September 13, 2021

Re: Hydraulic Analysis for
David Warren
11 New Meters Near Node 180
Sheet 37

* Sheet 37 *

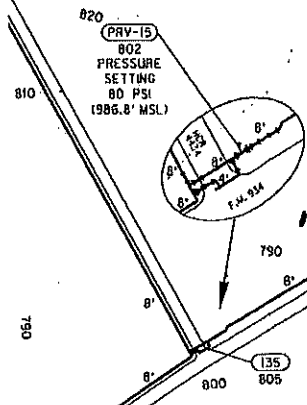
(11) Proposed mtrs.

* IF 11 meters cannot be
done, Mr. Warren would
like to know how many
can be supported *

Area of Property
(inside dotted lines)
* See Google map
included for
better details *

Our evaluation indicates that at this time a 6" water main will be required on the proposed interior street. The existing system can furnish the service in the conformity with Texas Commission on Water Quality standards.
